DOCKET 50-305
OPERATING LICENSE DPR-43
KEWAUNEE NUCLEAR POWER PLANT
NUCLEAR MANAGEMENT COMPANY, LLC. RESPONSE TO NRC 'S REQUEST FOR
ADDITIONAL INFORMATION ON WISCONSIN PUBLIC SERVICE CORPORATION
RELOAD SAFETY EVALUATION METHODS TOPICAL REPORT, WPSRSEM-NP,
REVISION 3

Response to NRC Questions Concerning Reload Safety Evaluation Methods

Figures 1 through 4 compare the pressure and temperature responses for runs 109,112,116,and 119 respectively. These comparisons show good overall agreement of the calculated results with the measurements.

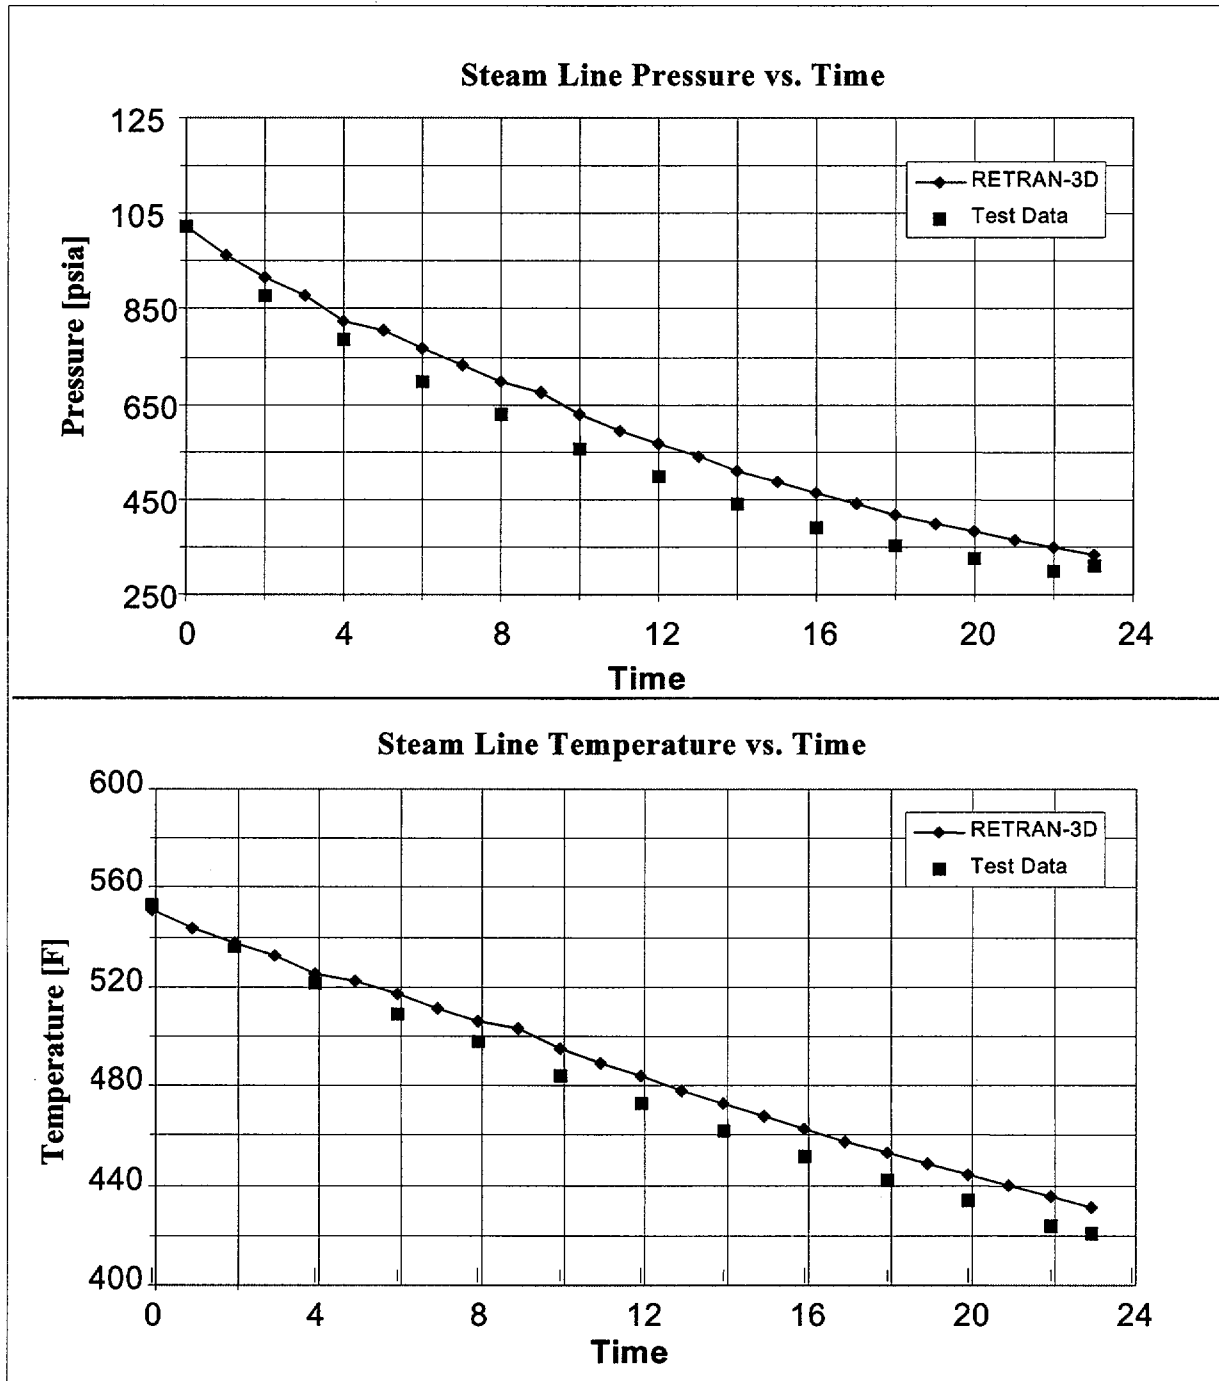
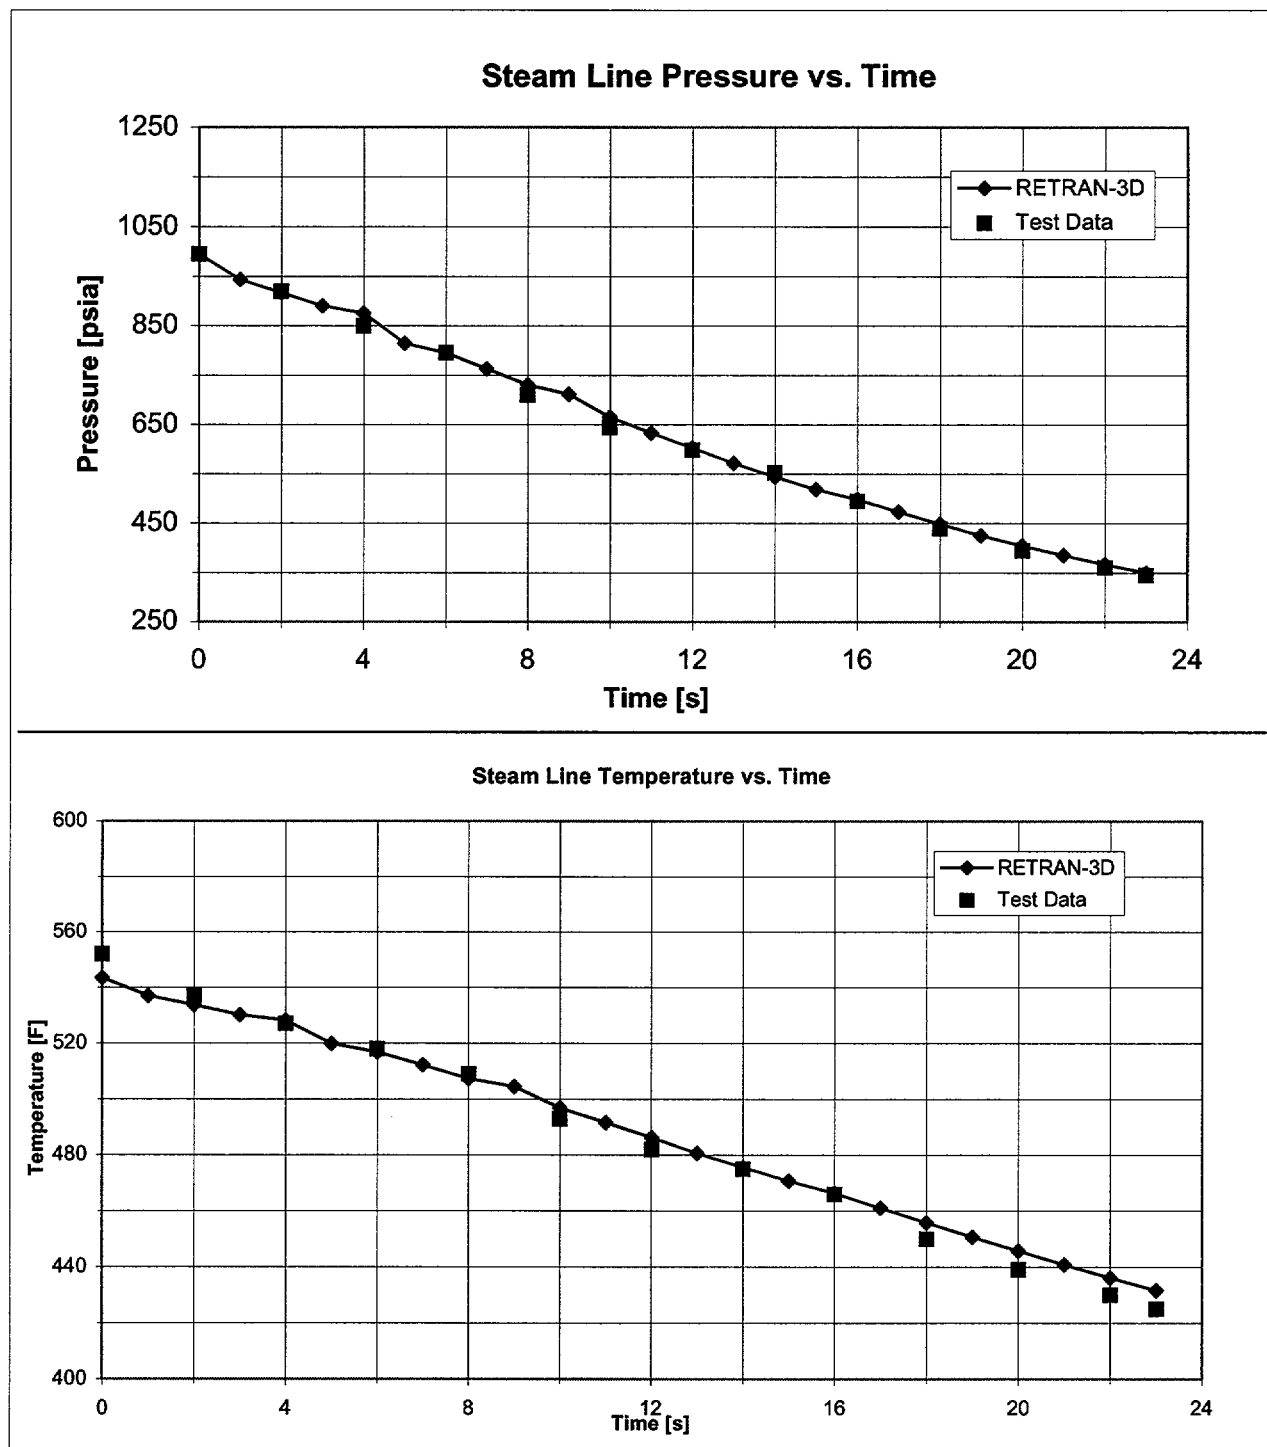
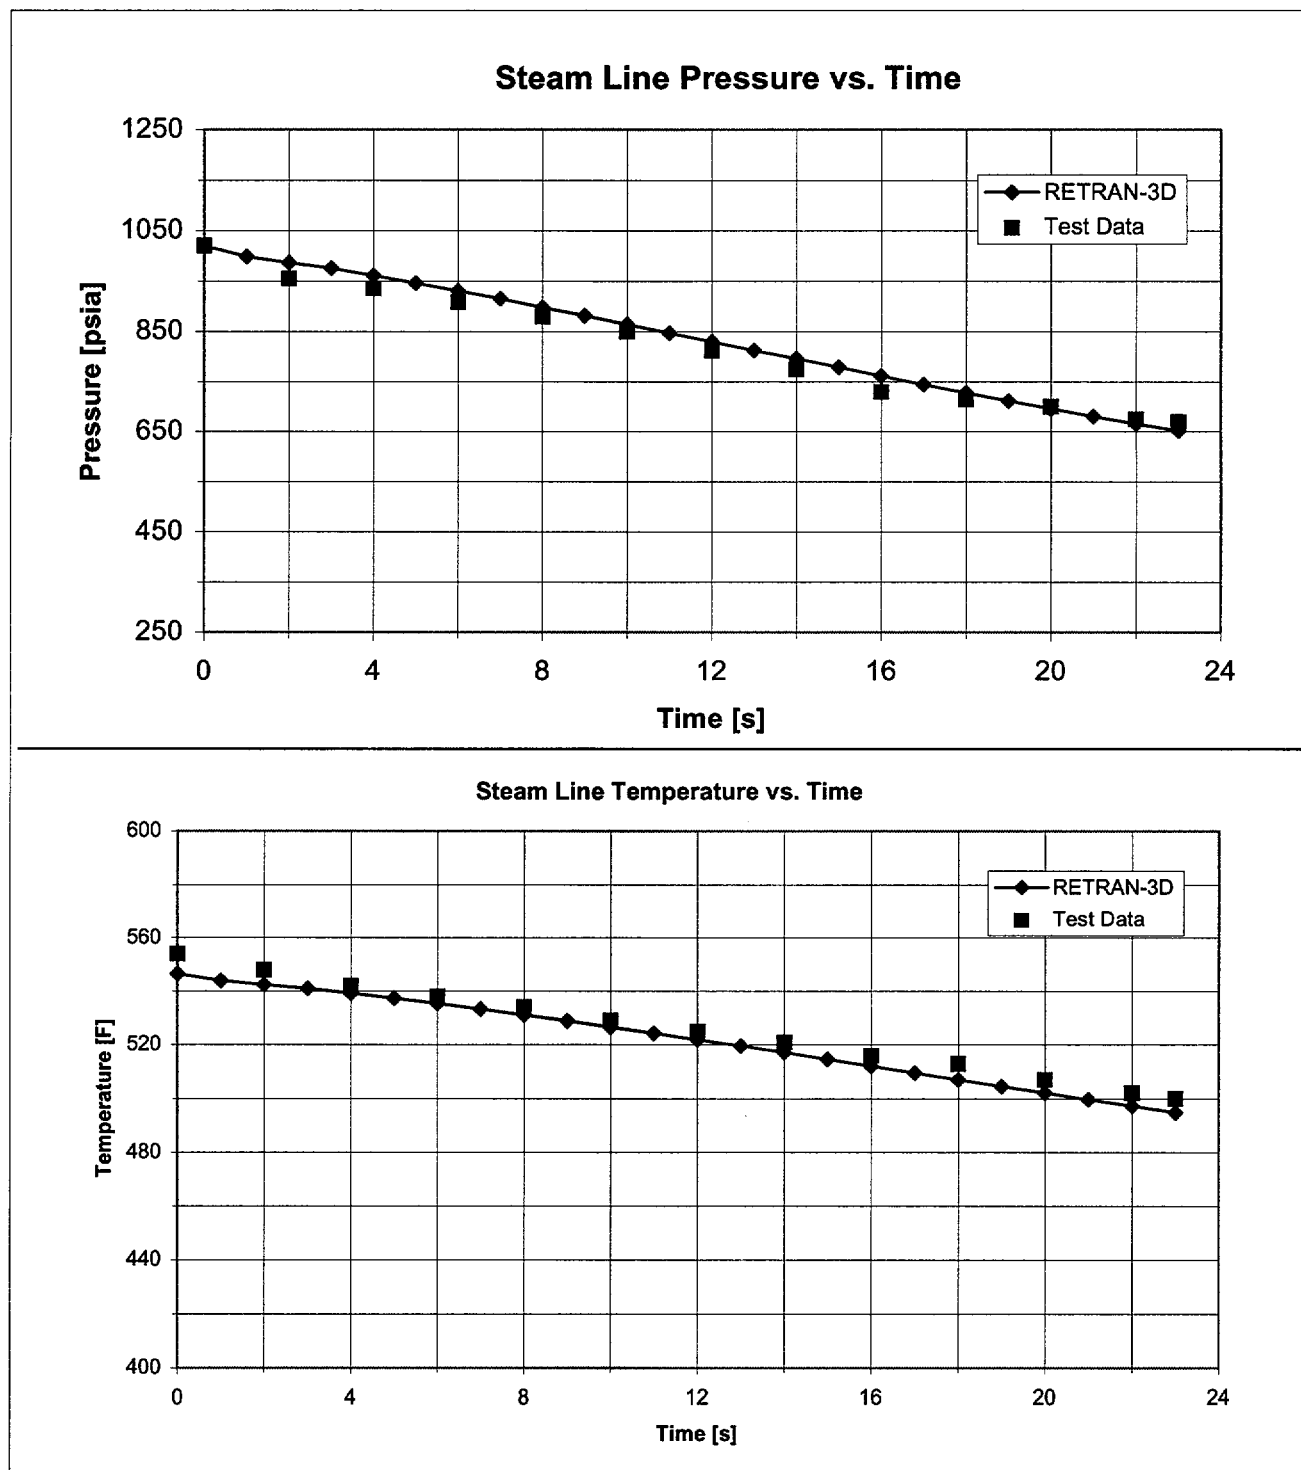
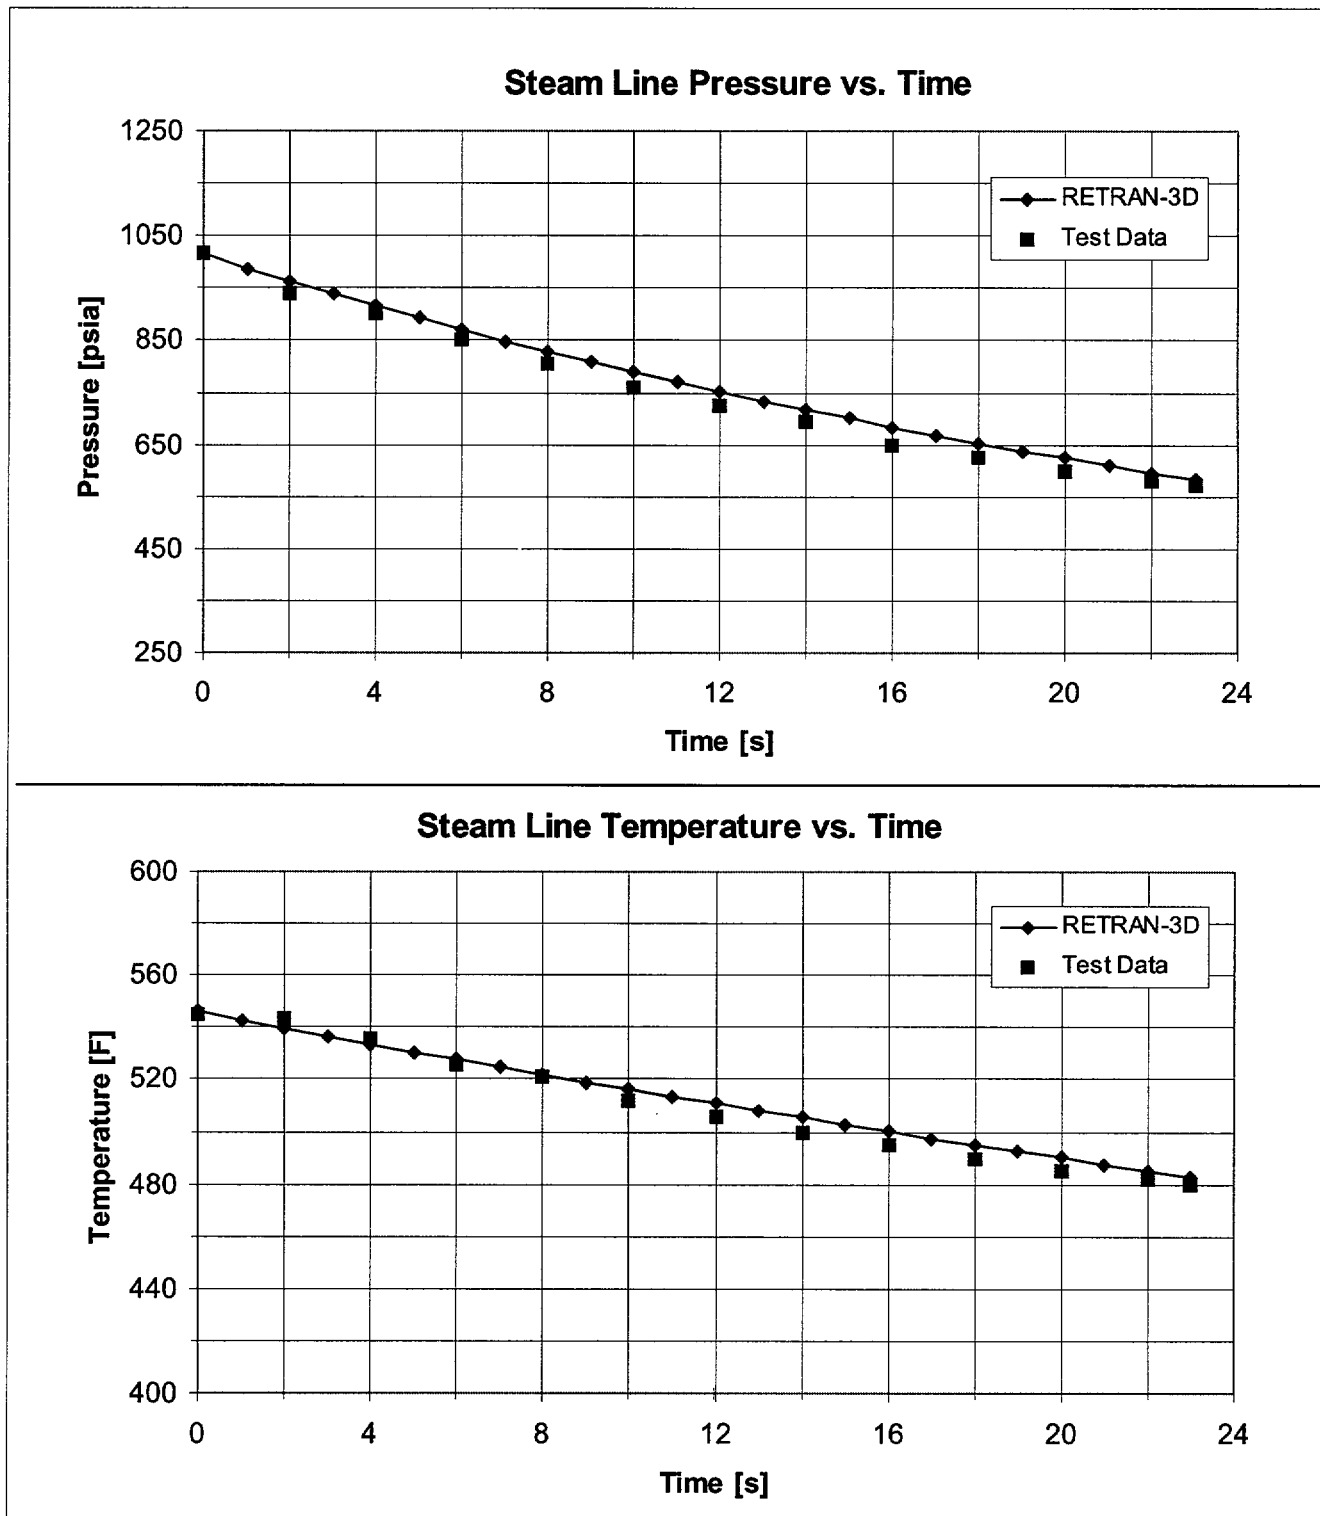
2.3.1 A comparison of RETRAN-3D steam generator model with experimental data

Steam Generator blowdown quality uncertainty factors were determined using a RETRAN-3D model of the Combustion Engineering (CE) experiments documented in reference 2-8. The RETRAN-3D calculated blowdown average quality results are compared with the CE measured results in Table 6.

The model underpredicts the average quality for the small break runs (runs 114 through 116) and overpredicts the quality for the large break runs (runs 109 through 112). There does not appear to be any trend with respect to initial water level. The model tended to overpredict the total mass and energy releases for those runs in which entrainment was observed.

Figure 5 – CE Test Rig RETRAN Noding Diagram
(not to scale)

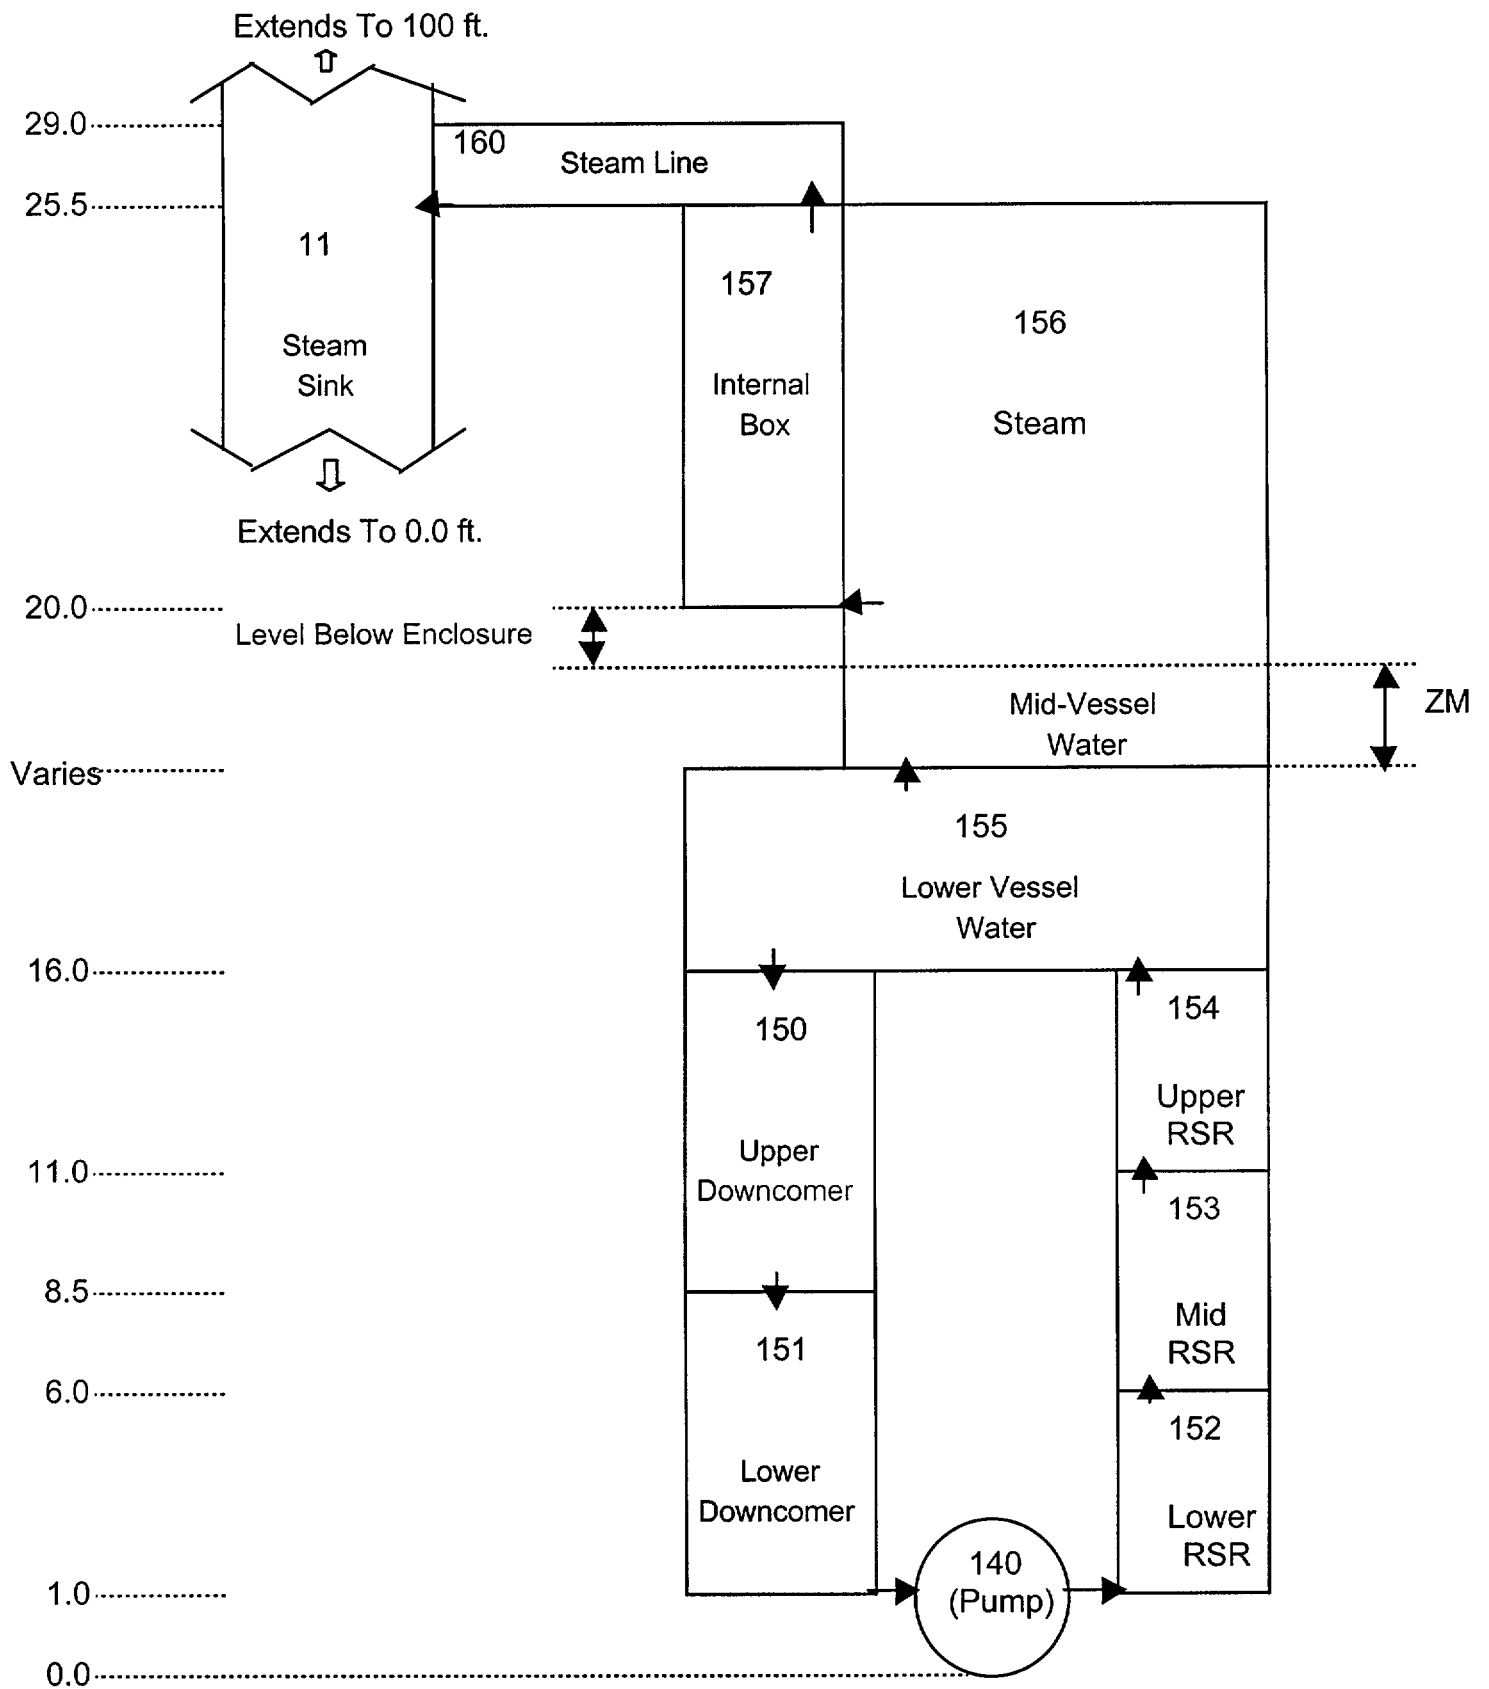
2.3.2 A drawing showing the RETRAN 3-D steam generator noding used for the experiment(s) and the Kewaunee steam generator

Figure 5 and 6 show the RETRAN-3D model steam generator noding used for the experiments and for KNPP steam generator respectively.
